SERVICE LETTER

No. 518

Subject: Modification of Exhaust Mufflers

Models Affected: PA-24-260 Comanches

Affected Muffler Assemblies

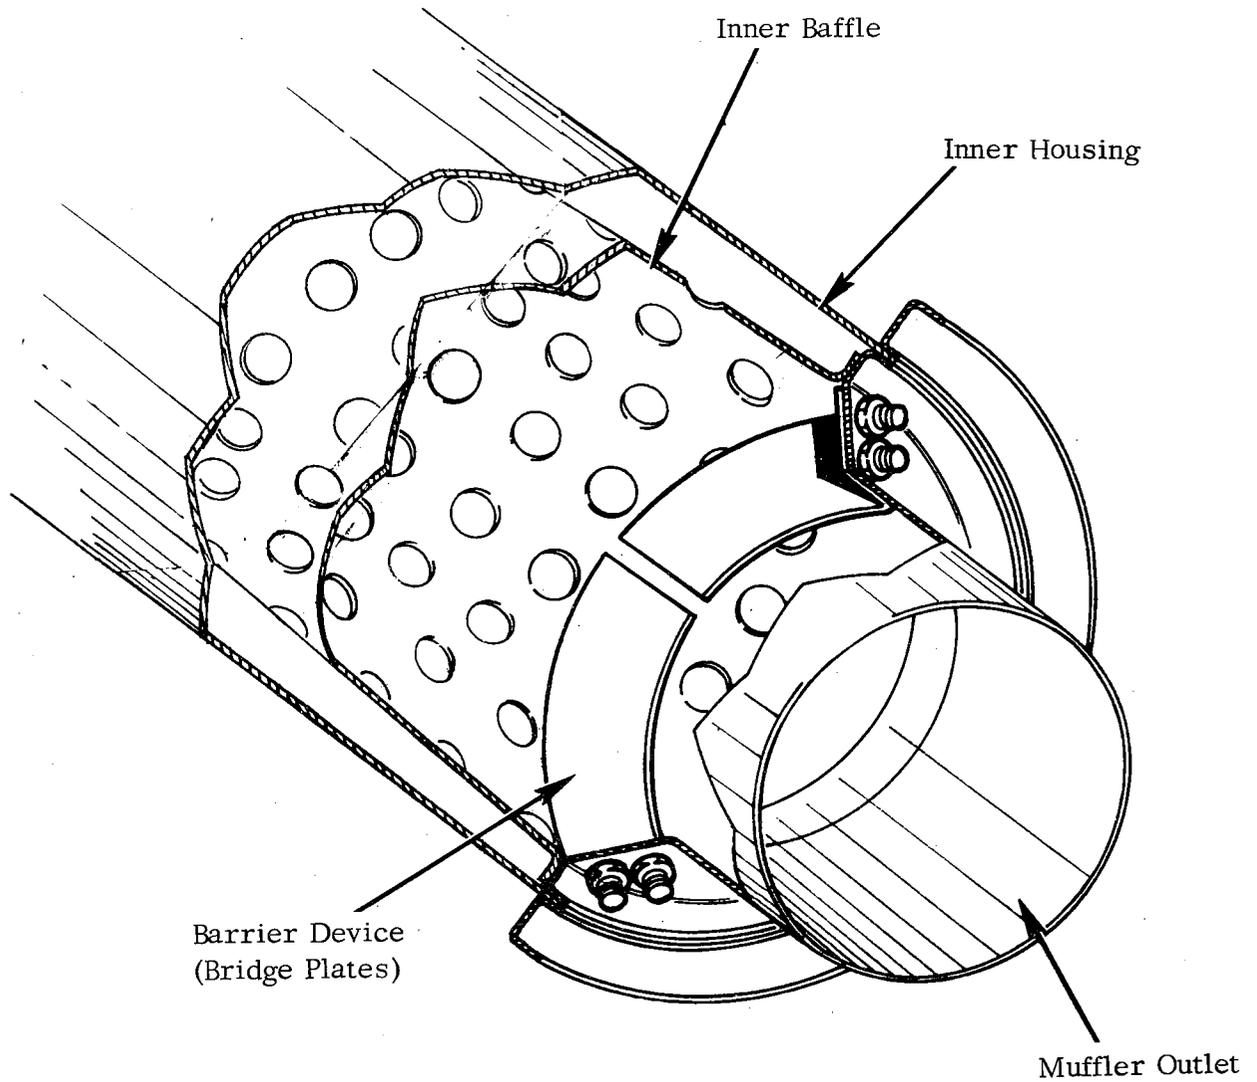
Purpose: To provide materials and instructions for installation of a barrier device on the inside of each muffler (see sketch attached to this letter for additional information).

The subject modification, in conjunction with an adequate exhaust system inspection program (see paragraph below), will minimize the possibility of engine exhaust restriction with resulting power reduction, in the event deterioration of the muffler inner baffle should occur.

New replacement exhaust mufflers which incorporate the barrier devices (contained in Kit No. 760 289) will have new part numbers assigned, as follows:

<u>Previous Part No.</u>	Superseded By	<u>New Part No.</u>
24863-00	" "	24863-08
24863-04	" "	24863-09
26345-02	" "	26345-05
26345-03	" "	26345-06
